PLANNING SCHEME AMENDMENT C190 ARDEN-MACAULAY

4 June 2013

Management's comments on each submission (summarised)**Table of Contents**

Figure 3

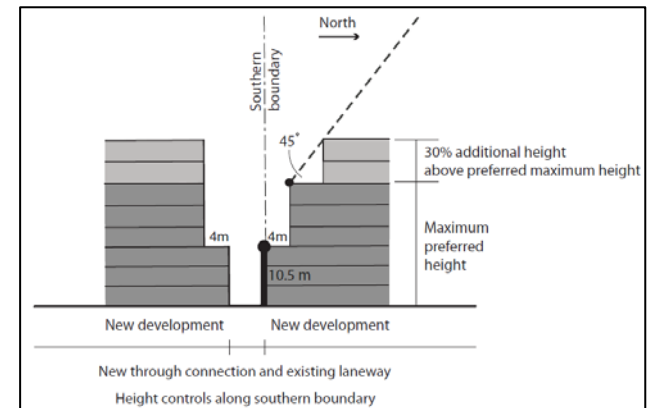
The submitter notes that figure 11 of the proposed DDO60 includes setback requirements for new developments north of Hardiman Street, in order to retain solar access to the private open space of single storey properties backing onto the south side of Little Hardiman Street. The submitter put to Council that appropriate building height and set-back guidelines for the entirety of Little Hardiman ought to be imposed and ought to extend to all residents (including those whose properties are not single storey dwellings and do not have a private open space along their boundary to Little Hardiman) the consideration which is currently proposed to be limited only to those residents whose properties accord with the requirements of Figure 11.

developments on the south side of the Little Hardiman Street east of Albermarle Street receive a reasonable level of daylight/sunlight

Management therefore recommends amending proposed DDO60 to more clearly state that the building envelope as shown on figure 3 should apply to new development backing onto an existing east-west laneway and to amend figure 3 by showing a 45 degree angle rather than 52 degree angle.

It should be noted that modelling shows that if this requirement is complied with by new developments north of Little Hardiman Street, the submitter's private open space located at the southern end of his property (i.e. along Hardiman Street) will not be further overshadowed at the equinox than is currently the case.

Figure 3

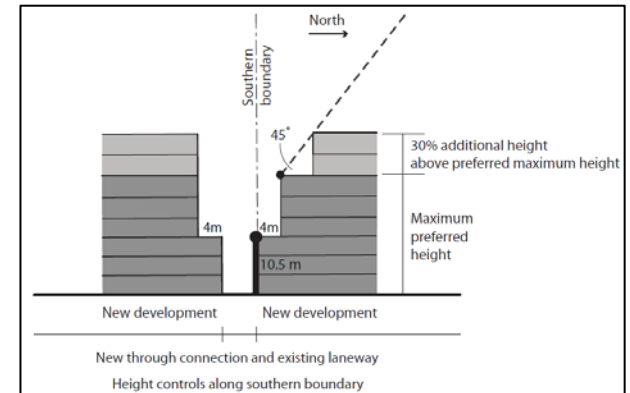
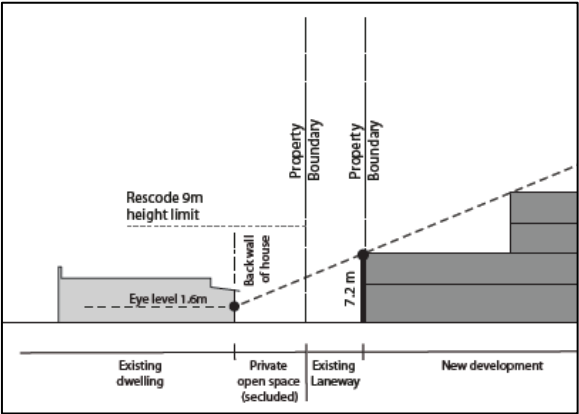
No.	Submitter	Summary of submission	Management comments
		<ul style="list-style-type: none"> • What will happen to the few small parks in the area? Will Kensington become a concrete jungle? <p>The submitter believes the current problems need to be sorted out before you add more issues to the area, and tall building could be concentrated in Docklands where it will not impact on well established residential areas</p>	
64	Petra Muhlfait	<p>The submitter has the following concerns:</p> <ul style="list-style-type: none"> • The proposed building heights are excessive and adversely affect amenity via overshadowing, denying access to daylight and potential overlooking. • Developments of this scale will adversely impact on already existing parking and traffic flow issues. • Use of Little Hardiman Street could increase and create noise, pollution and safety concerns, this lane is not suitable for an increased volume of traffic • The proposed scale and style of buildings is out of keeping with the character of the neighbourhood. • Figure 11 to DDO60 allows for setbacks to retain solar access to private open space for single storey properties fronting Hardiman Street and extending to Little Hardiman Street at their rear. No such allowances have been made for the submitter's property. Access to light is already limited. A setback should be incorporated to protect direct solar access. 	<p>Scale, bulk & density – See attachment</p> <p>Parking - See attachment</p> <p>It is proposed to apply figure 11 of the proposed new DDO60 to new developments that back onto Little Hardiman Street west of Albermarle Street, given that Little Hardiman Street separates these potential new developments from low scale residential properties, which have their north facing private open space backing onto Little Hardiman Street.</p> <p>East of Albermarle Street, the form of existing development and the current zoning (Mixed Use Zone) are different and provide the potential for new developments both north and south of Little Hardiman Street. It is however important that developments on the south side of the Little Hardiman Street east of Albermarle Street receive a reasonable level of daylight/sunlight</p> <p><i>Management therefore recommends amending proposed DDO60 to more clearly state that the building envelope as shown on figure 3 should apply to new development backing onto an existing east-west laneway and to amend figure 3 by showing a 45 degree angle rather than 52 degree angle.</i></p>

It should be noted that modelling shows that if this requirement is complied with by new developments north of Little Hardiman Street, the submitter’s private open space located at the southern end of his property (i.e. along Hardiman Street) will not be further overshadowed at the equinox than is currently the case.

Figure 9

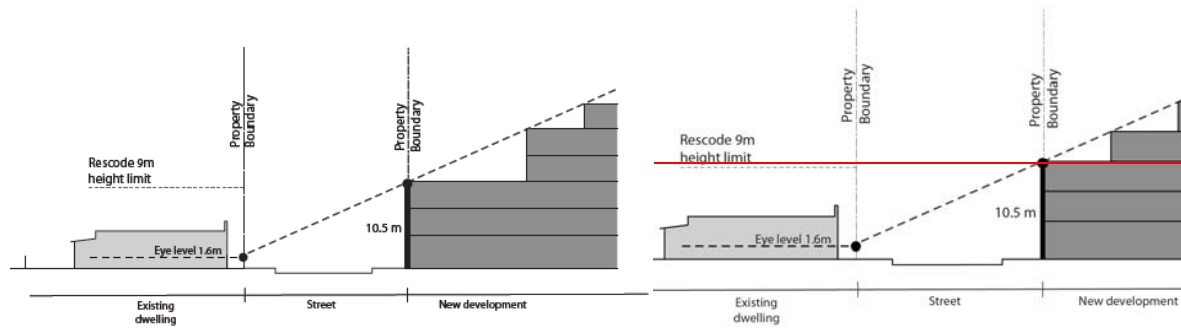
3	Hadyn Sharples	Concerned about effects on transport, both road and public transport, of increased population. Already difficult to get on a peak hour train at Kensington Station and Macaulay Road is already in gridlock most of the day.	<p>Public transport and traffic – See attachment</p> <p>No changes to the Amendment are required in response to this submission.</p>
4	Michael Paszylka	The submitter considers that there is an inconsistency in the height limits at the corner of Canning and Melrose Streets where a preferred maximum overall building height is proposed and where any part of a building above 20 metres will need to have a minimum setback of 10 metres from Canning Street but no setback from Melrose Street is currently proposed. The submitter considers this inappropriate given that lower scale properties are currently located on the east side and given the stated aim of “providing lower heights near existing low rise neighbourhoods to help maintain the amenity of these areas and ensure that new buildings are respectful of existing buildings”.	<i>Management acknowledges this inconsistency and recommends that, given the sites’ interface with the low scale development on the east side of Melrose Street, the built form requirements for Area 10 in DDO60 be amended so that new development on the north-west corner of Canning and Melrose Streets be required to have a maximum height at street edge of 10.5 metres along Melrose Street and that the building</i>

No.	Submitter	Summary of submission	Management comments
		property.	Views are not a planning consideration. No changes to the Amendment are recommended in response to this submission.
8	Jarrod Sawers	<p>Proposed heights (particularly concerned about those along the Macaulay Road and Stubbs Street areas) are significantly larger than current buildings and have the potential to overshadow and dominate submitter's property. Submitter is also concerned with the protection of their privacy from overlooking and believes the scale of buildings proposed will be out character with the neighbourhood, thereby impacting on the amenity.</p> <p>Car access to & through Kensington is currently constrained by high traffic congestion created by the bottlenecks at railway crossings on Macaulay Road. This issue needs to be addressed prior to the approval of any significant increase in population density.</p> <p>While the area has access to multiple forms of public transport, these services are currently inadequate, with train services at Kensington at capacity during an extended peak period each day, weekends and during special events (such as racing) and Macaulay station needing a significant upgrade to service, amenity and, most importantly safety. The submitter believes that it is also unreasonable to expect that residents and new residents will rely solely or predominately on public transport for their transport given that most parts of Melbourne cannot be easily accessed by public transport and local trips for shopping or doctor visits, particularly families with young children, are unsuited to public transport.</p> <p>The submitter is also concerned about the increase in local traffic congestion arising from this proposal. The submitter states that there is already significant 'back street' traffic congestion (on road and parking) in Robertson, Collett, Lambeth, Barnett & Smith Streets, and this will only be compounded by the number of new residents and visitors involved in this proposed scheme.</p> <p>The creation of further schools and community services (such as YMCA) is required as these are currently under pressure.</p> <p>The submitter is concerned that there is a lack of open spaces provided for in the plan, as a growing population brings the need for parkland spaces for</p>	<p>The submitter's property is not subject to the amendment although the property across Robertson Road to the south is.</p> <p>In order to ensure an appropriate transition between the north and southern sides of Robertson Road a maximum height at street edge and preferred minimum setbacks should be specified. As shown on the diagram below, a street wall height of 10.5m with any part of the building above 10.5 metres being below the line of sight as shown on figure 9 will ensure that new development on the south side of Robertson Street does not visually overwhelm development on the north side.</p>  <p>Figure 9</p> <p><i>Management recommends changes to the Amendment to ensure the controls for Area 3 explicitly require compliance with figure 9, i.e. mandatory maximum height at street edge of 10.5 metres and building envelope should be within the line of sight as shown in figure 9.</i></p>

No.	Submitter	Summary of submission	Management comments
			<i>envelope when viewed from Melrose Street should comply with Figure 9, which deals with new developments fronting onto a street separating it from existing residential.</i>
5	Andrew Thomas	The submitter supports the amendment	No changes to the Amendment are required in response to this submission.
6	Francesca Bate	<p>The submitter is concerned that a height control of 10.5 metres is proposed for the property directly behind theirs and on the other corner of Smith and Lambeth Streets. This would result in a loss of privacy should a two storey house be allowed to be built on the property behind them and loss of morning sun in their backyard should a two storey house be allowed to be built on the property on the other side of Lambeth Street.</p> <p>The submitter is also concerned about height controls of up to 14 metres and 20 metres being proposed further east (towards Stubbs Street) along the southern side of Smith Street. The submitter considers that buildings of up to about 6 storeys in that location would be out of all proportion height-wise to the rest of the suburb. They do not think six storeys would be appropriate for the area around Smith Street from Robertson Street up to Parson Street and that a maximum of three storeys would be enough.</p>	<p>Neither the submitter's property nor any properties directly opposite or adjoining are affected by the amendment.</p> <p>The submitter's property and those surrounding it are in a Residential 1 Zone and should any of these properties be redeveloped, ResCode would apply and overlooking, overshadowing and other matters would be considered in determining the application.</p> <p>Scale, bulk & density – See attachment</p> <p>No changes to the Amendment are recommended in response to this submission.</p>

Figure 10

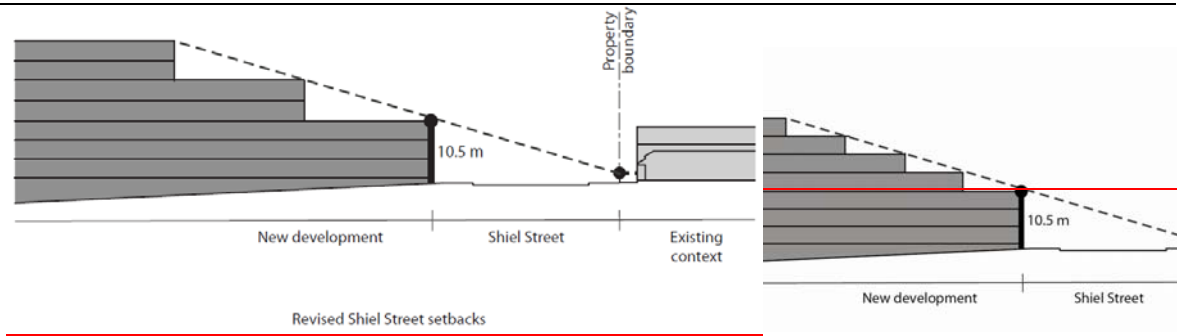
No.	Submitter	Summary of submission	Management comments
		<p>height, bulk and massing and will not provide a transition/interface from the low-scale existing residential character of Shiel Street.</p> <p>Figure 10 has also deleted the 'limited of discretion' dashed line from the Arden Macaulay Structure Plan's Figure D, because C190 allows heights to exceed this dashed line.</p> <p>These changes are deceptive and misrepresent the Structure Plan.</p> <p><i>Detrimental Impact on Gardiner Reserve</i></p> <p>DDO60 Area 11 proposes a maximum building height of 14m at Haines Street with only a 14m setback before building heights of 30m/39m area allowed. Gardiner Reserve will suffer overshadowing from 4-6 storeys. Council has failed to show any overshadowing calculations that would prove building 30m-39m and setback only 14m would meet its many criteria for protecting public open spaces.</p> <p>Building Heights in Area 11 along Haines opposite Gardiner must be reduced so that Gardiner Reserve is no overshadowed.</p> <p><i>New laneways/through connections</i></p> <p>It is suggested that the wording of in this section be amended to allow some leeway as to where new laneways are located within a development site and be reworded as follows:</p> <p><i>"New laneways or through pedestrian connections will be required for some sites. Map 2 shows the <u>indicative</u> location of the new laneways/through connections.</i></p> <p><i>New laneways/through connection should be:</i></p> <ul style="list-style-type: none"> • <i>Safe, direct and attractive</i> • <i>Etc"</i> <p>The rewording is important as proposed through connections may impact on existing infrastructure or street trees i.e. the proposed through connection to the southern side of Shiel Street would come close to existing mature trees (part of the heritage graded tree avenue).</p>

envelope from street:
should be within the
45degree angle as show in
figures 1, except for
development along Shiel
Street where it should be
within the line of sight as
shown in figure 10 and
Haines Street where any
part of building above 14
metres should have a
setback of 14 metres.

~~Setbacks to Shiel Street
must be in accordance
with figure 10 (Interface
Area—Shiel Street)~~
